13 March 2020

Alternative solution to Flora Dora stormwater management

Fig 2 NE aspect

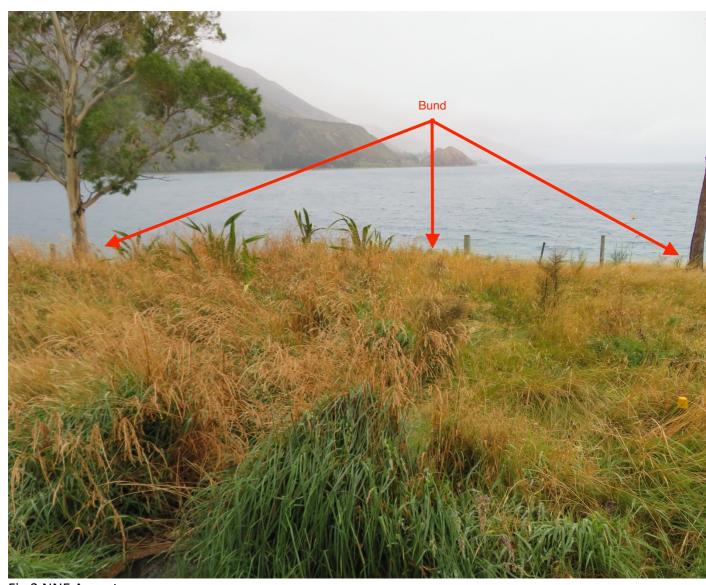
The area will increasingly become a pleasant natural area of native plants and thus assist wider efforts to enhance biodiversity. We consider this aspect is worth protecting and enhancing. In that regard we see the proposed engineering solution as being: 1) 'urban' like and not appropriate for the site, 2) does not address the issue of contaminants, and 3) unnecessarily expensive.

Rather we wish to suggest a more natural solution and cheaper option, namely a semi-wetland with an exit point and socket on its northern aspect. The wetland would be created by constructing a east/west arching bund immediately south of the existing fence (see Figs 2-4). The contained area could be planted out with further wetland native plant species thus enchancing filtering effects and native biodiversity. The bund could also be planted.
